Parks Canada Agency  
Repair of lock #9, Canal-de-Chambly  
Project N° CCHM 1446  
Addendum n° 03

**PRECISIONS AND AMENDMENTS ON PLANS AND SPECIFICATIONS**

Following questions from the bidders (Q.), the following replies (R.) are provided as precisions and amendments to the drawings and specifications.

Bathymetry Survey downstream of Lock #9 (2001)

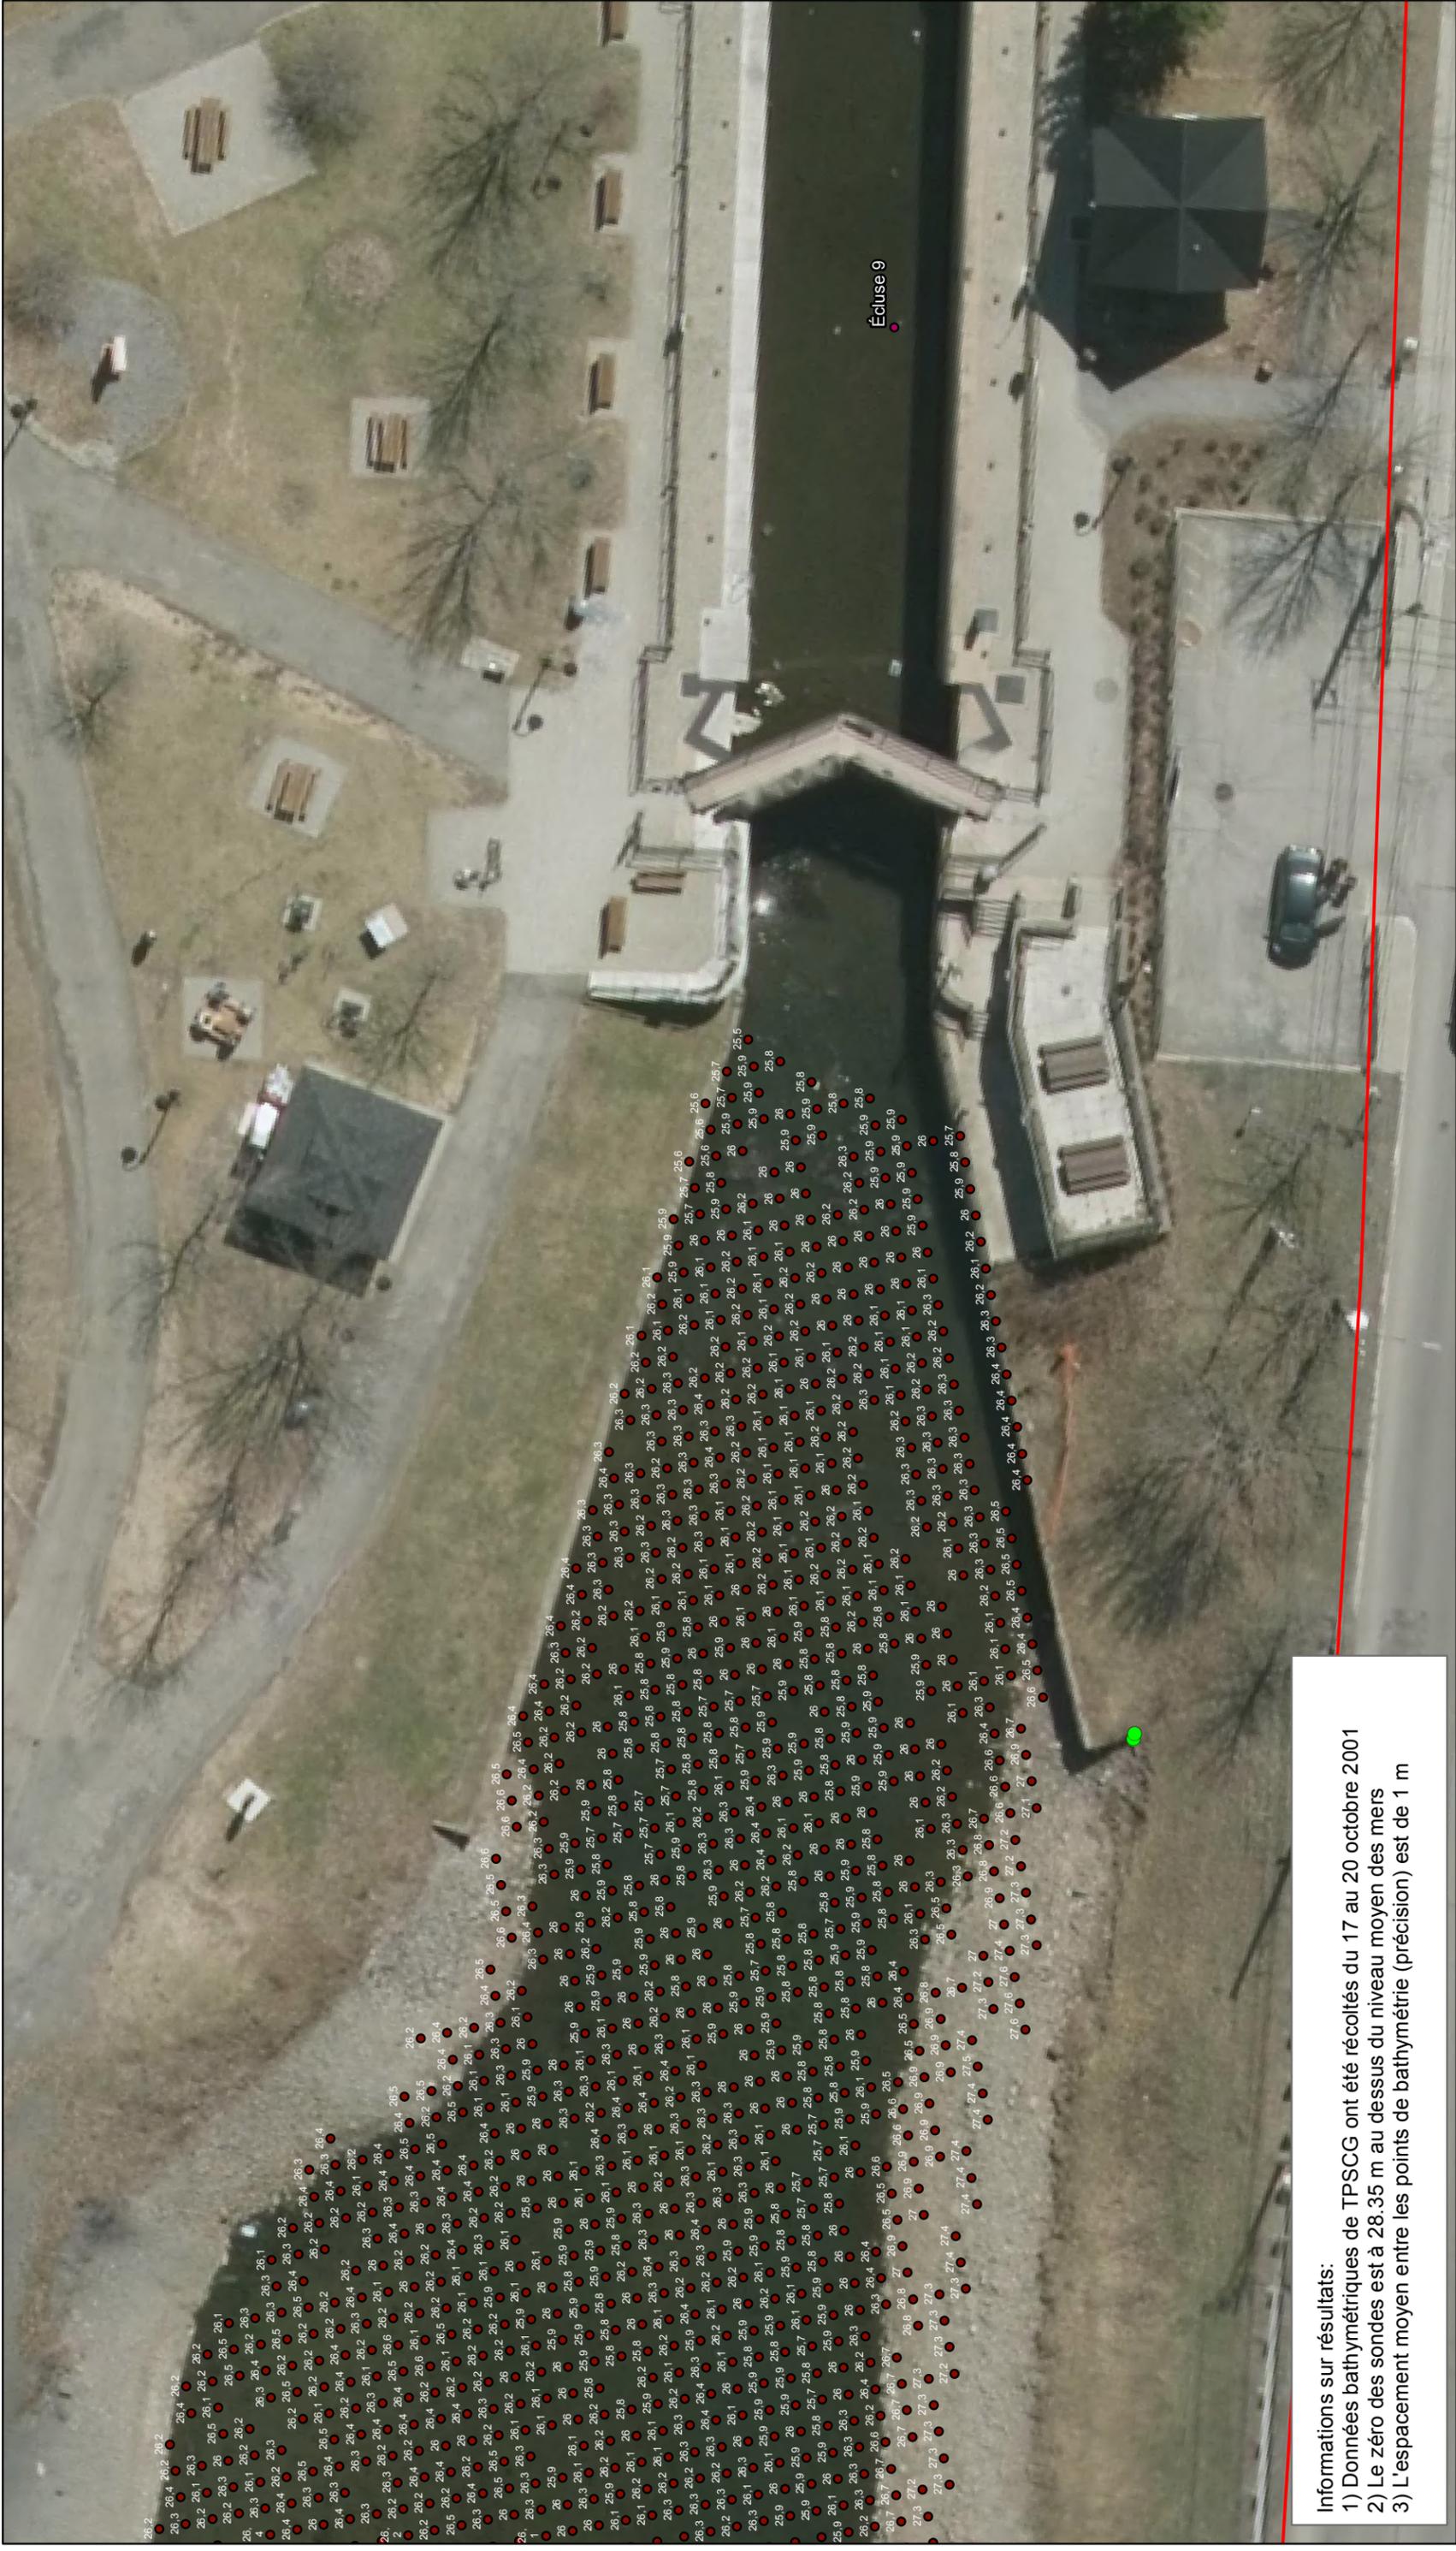
**Q. :** What are the levels of Canal Bed and water depth at the various work sites (upstream, downstream and downstream injection areas)?

- Only one Cofferdam height is specified at 1,5 m in the Contract Documents...please clarify.

Water level of the downstream Reach shows important fluctuations depending on weather conditions and period of year. The average low-water level corresponds to approximately 100 mm above the top of downstream Lock Doors sill, and the average high-water level corresponds to approximately 900 mm above the downstream sill. Final total height of cofferdam depends on the location chosen by the Contractor. Final total height of cofferdam will depend on the water depth at the cofferdam location, due to local variations of the level of Canal Bed downstream of the Lock, and on the Contractor's choice to use only one cofferdam to ensure dry conditions of all work areas or use several cofferdams: a first one approximately 5 m downstream of the downstream doors, for the drydock of the Lock, and others to locally isolate and ensure dry conditions for the injections work zones on the downstream walls.

A bathymetry survey was conducted in 2001 over the area downstream of Lock #9. General profile results are shown in Annex 1 of this Addendum for information purpose to bidders. Bidders shall include contingencies as this survey dates back to 2001 and profile of Canal Bed might have changed since.
